**BEFORE THE PUBLIC UTILITY COMMISSION
OF OREGON**

LC 81

2023 Integrated Resource Plan.

ORDER

Figure 1: Comparison of Green Hydrogen Cost Trajectories

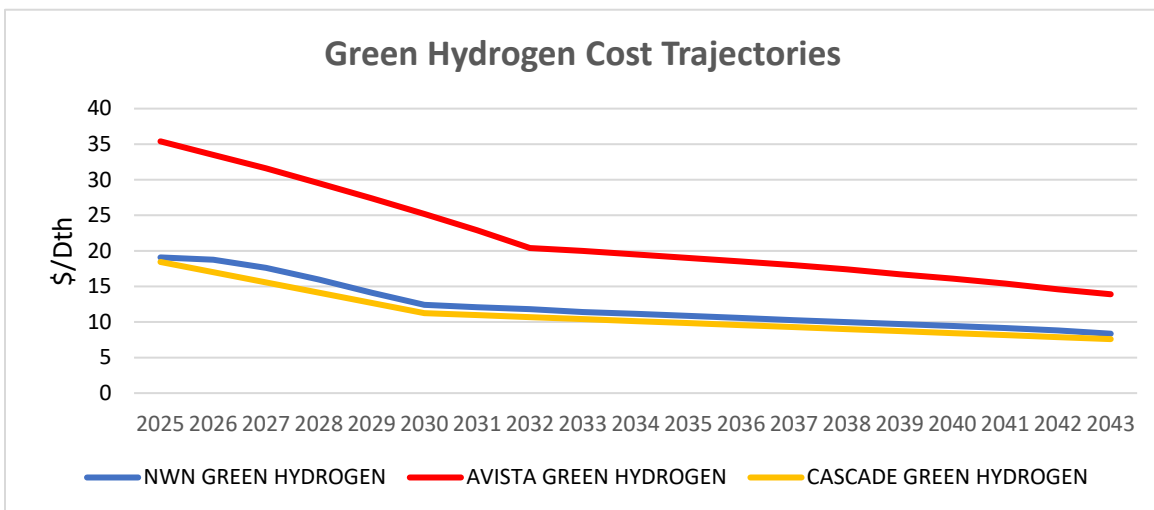
Staff agrees with CUB’s assessment of the risks associated with synthetic methane, however, differs slightly regarding CUB’s assertion that Avista needs to rely on an “established method.” Staff supports Avista’s efforts to project new supply side resource costs and availability and encourages Avista to explore and critique objective third-party sources that could be used to project costs and availability as part of the TAC process for developing future IRPs. While Avista’s estimates for green hydrogen costs as a feedstock to synthetic methane are conservative when compared against NW Natural and Cascade, as shown in Figure 1,⁷ Staff remains concerned about the Company’s ability to produce or procure the green hydrogen required to produce synthetic methane at the scale projected by Avista in its IRP.

*Figure 2:
Comparison of
Dairy RNG IRP
Estimate and RFP
Bids*

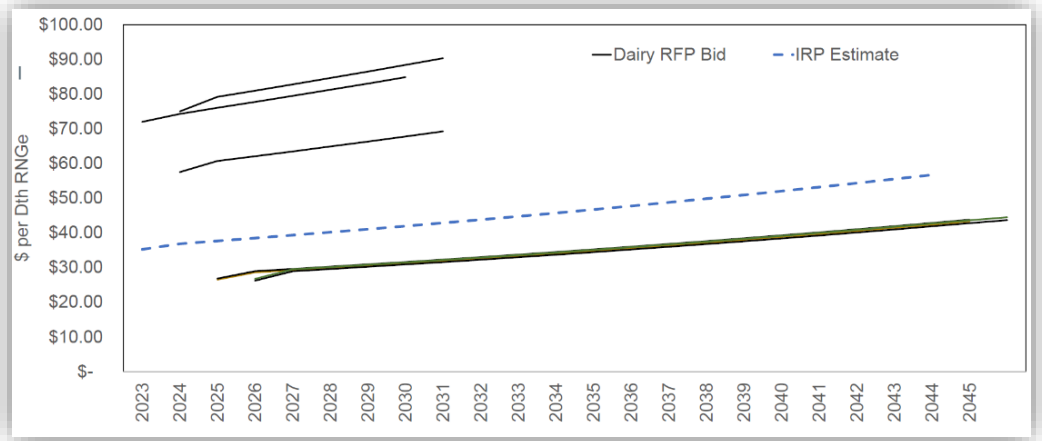
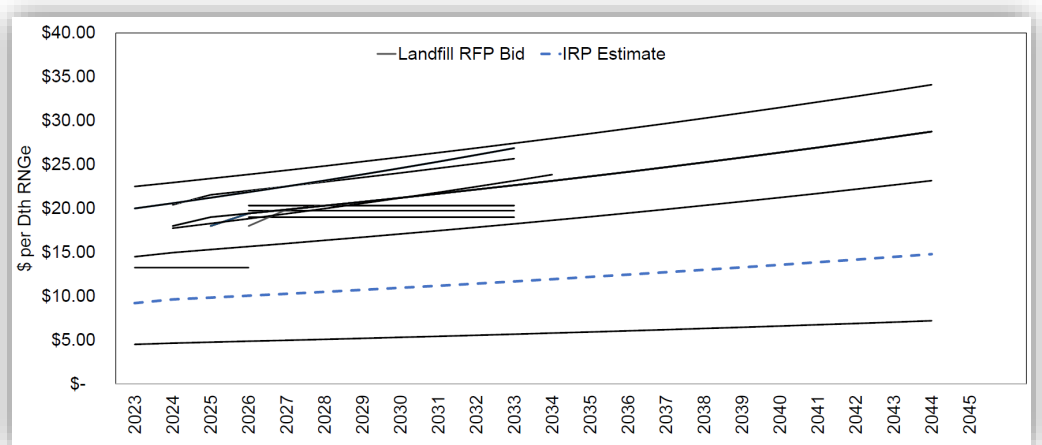
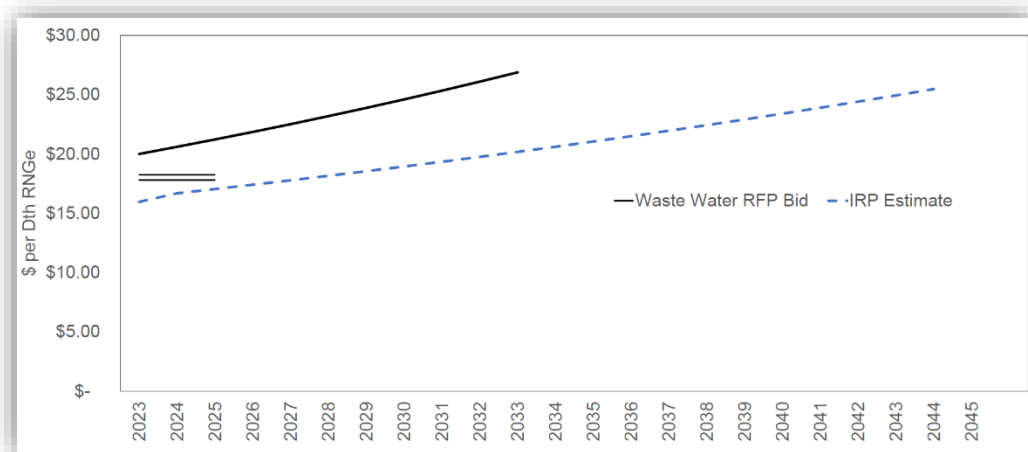
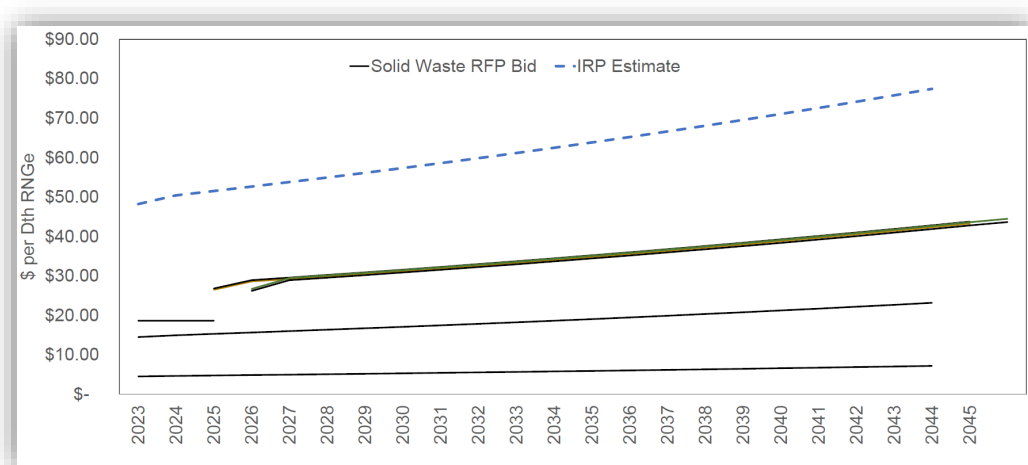
Avista addresses Staff’s request regarding how cost assumptions have changed since the 2018 Black & Veatch report by providing four charts comparing RNG pricing of the “IRP Estimate” derived from the report versus RFP bids Avista received.²² Of the four charts, only Avista’s solid waste IRP estimate is perceivably higher than then RFP bids. Avista’s IRP estimate for landfill and wastewater RNG is much lower than at least a majority, if not all the RFP bids. Dairy is likely closer to the middle of pricing based on the RFP bids, but without detailed workpapers, also appears perceivably lower than average. Avista states that the RFP prices consider market factors including Low Carbon Fuel Standard (LCFS) and Renewable Identification Number (RIN) program in the bid price.

Staff agrees with CUB that the RNG pricing is unreasonably low and that this undermines the Oregon PRS and IRP long-term plan generally.²³ While RNG is not the Company’s primary CPP compliance resource, it remains a consistently large resource in the PRS, starting in the near-term and maintaining importance throughout. If the resource is being underpriced, this could have negative impacts particularly on utilization of CCI and DSM programs, each of which represent smaller portions of the resource mix. The RNG cost comparison charts provided by Avista reinforces this concern. IRP RNG pricing that does not include important market factors, including LCFS and RIN program pricing, are unreasonably low and do not accurately represent the cost of RNG, therefore, lead to RNG to potentially overcrowding the Company’s Oregon PRS

Figure 6: NW Natural meter counts showing the return of a 2011-2015 trend of where meters decline in Q2-Q3 before rebounding in Q4 and Q1. The trailing 12-month growth rate is also at an all-time low since 2012.

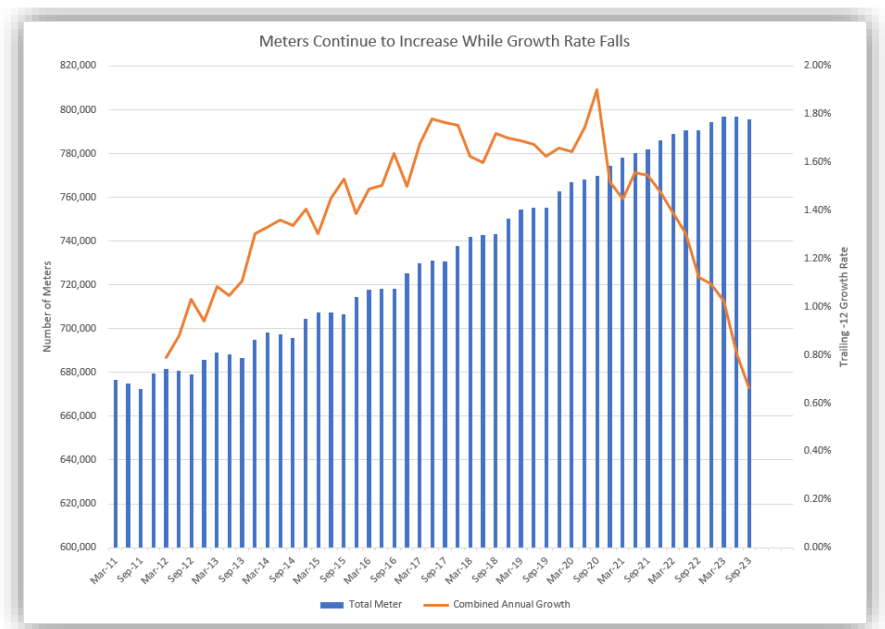
To start to understand baseline electrification occurring naturally, Staff recommends Avista use advanced metering infrastructure data and Form 10Q data to capture customer behavior. By the next IRP, Avista should present that information in the worksheet template included as Attachment B. An example of captured customer behavior from NW Natural’s Form 10Q is shown in Figure 6. This graph shows that even as meters increase, growth rate falls, suggesting increased energy efficiency measures and the natural electrification of end-uses. Such data can then be used

Figure 7: Forecast Space Heat Costs

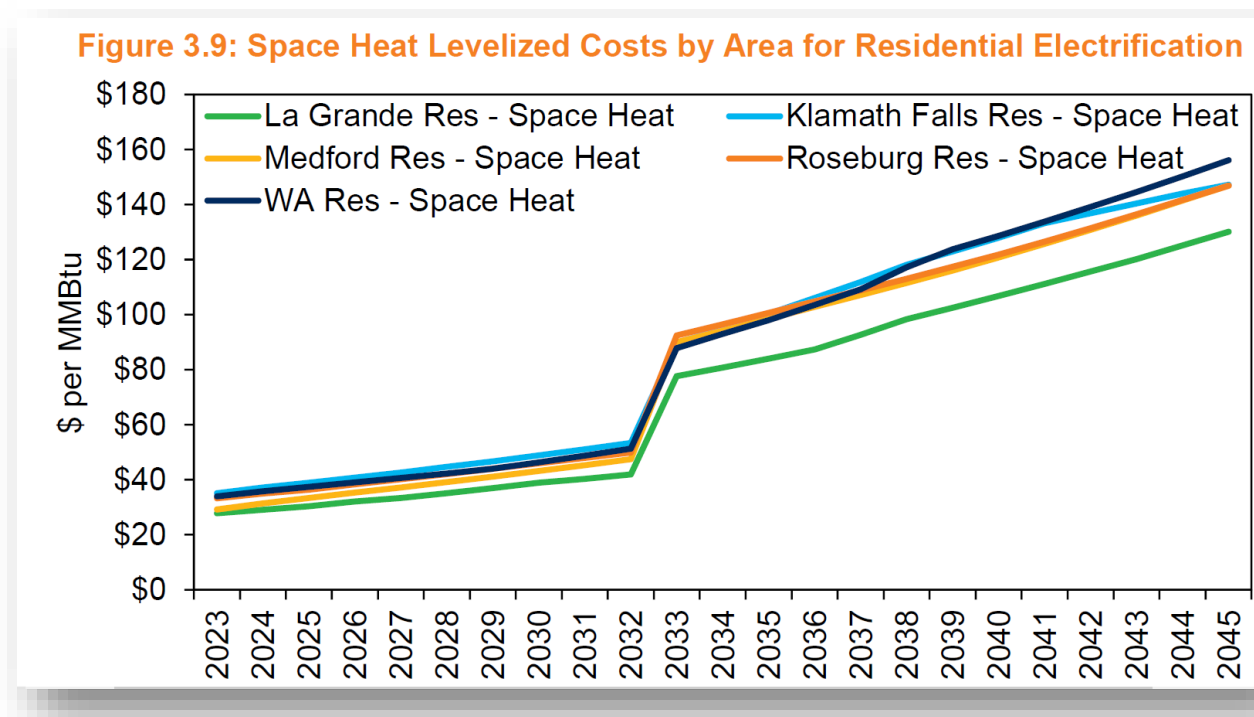
Figure 7 below shows Avista's forecasted cost for electric space heat inclusive of a 50 percent reduction in conversion costs for IRA incentives and increasing electric rates.¹⁴³
